Minutes – Executive Policy Committee – February 13, 2018

Item No. 8 Request to Amend Agreement AG 36/04 (Addendum to Development Agreement AG 1/95) for 147 Nordstrom Drive – rear yard set-back – File Nos. AG 36/04 (DASZ 36/2004) (St. Boniface Ward)

Title: **Request to Amend Agreement AG 36/04 (Addendum to Development Agreement AG 1/95) for 147 Nordstrom Drive – rear yard set-back – File Nos. AG 36/04 (DASZ 36/2004)**

APPENDIX "A" – Request to Amend Agreement AG 36/04 (Addendum to AG 1/95) for 147 Nordstrom Drive

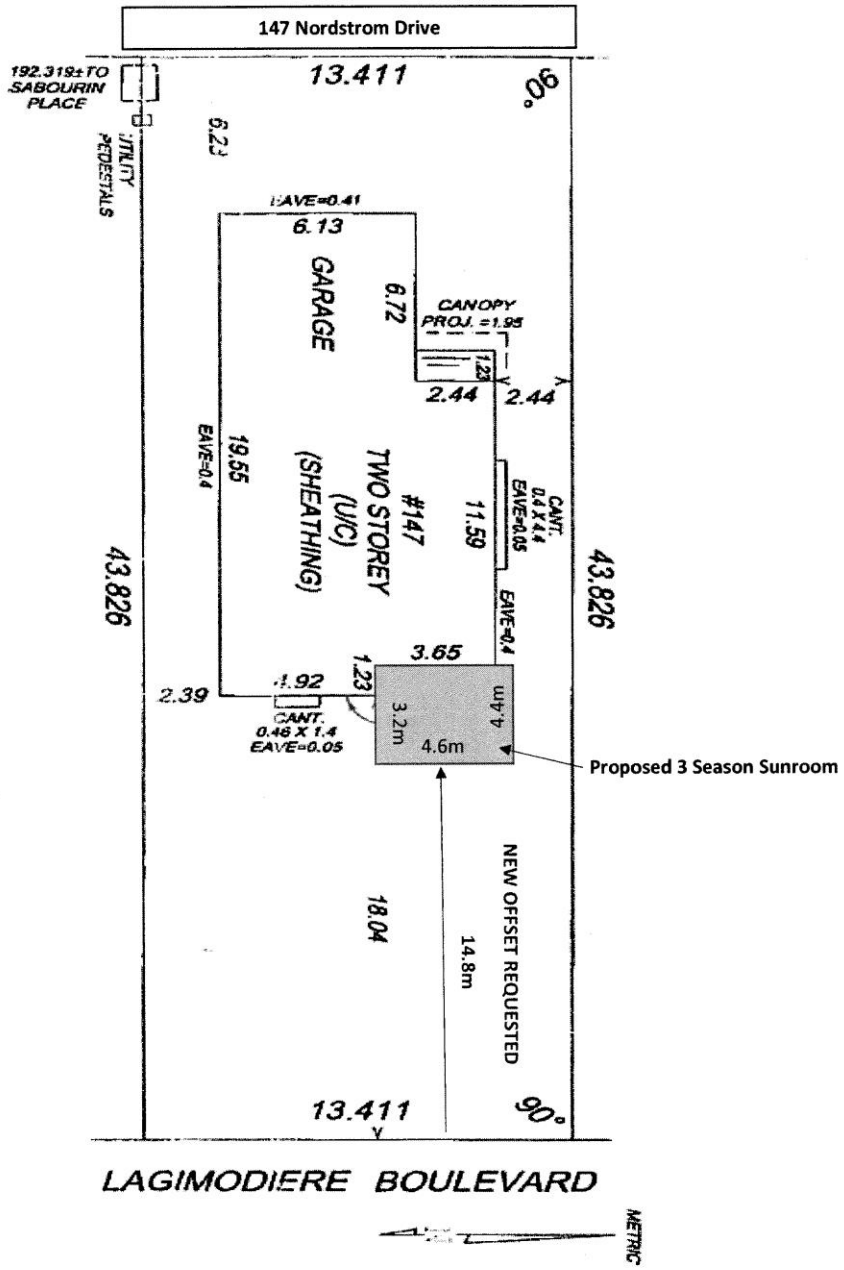
We would like to request, for consideration, an amendment to the Development Agreement caveated to our lot as it relates to the minimum rear yard setback of 17.5 m. Specifically, we are requesting that the current minimum rear yard setback of 17.5 meters be amended to 14.8 meters to allow for the construction of a 3-season sunroom.

In an effort to facilitate our request, we have attached a copy of our current status of title, along with a plan view sketch overlaid onto our surveyor's building location certificate to demonstrate the location and measurements of the proposed 3-season sunroom and new rear yard off-set.

147 Nordstrom Drive
192.319± TO SABOURIN PLACE
UTILITY PEDESTALS
13.411
90°
6.23
EAVE=0.41
6.13
GARAGE
6.72
CANOPY PROJ. =1.95
1.23
2.44
2.44
19.55
EAVE=0.4
TWO STOREY (U/C) (SHEATHING)
#147
11.59
CANT. 0.4 X 4.4 EAVE=0.05
EAVE=0.4
43.826
43.826
3.65
1.23
1.92
2.39
CANT. 0.46 X 1.4 EAVE=0.05
3.2m
4.4m
4.6m
Proposed 3 Season Sunroom
NEW OFFSET REQUESTED
14.8m
18.04
13.411
90°
LAGIMODIERE BOULEVARD
METRIC

"9.1 Notwithstanding Clause 9 of this agreement, the proposed sunroom addition to the rear of the existing dwelling on Lot 37, Block 1, Plan 44824 shall be set back a minimum distance of 14.8 metres from the rear property line abutting the boundary of Lagimodiere Boulevard (formerly Melnick Road) instead of 17.5 metres."
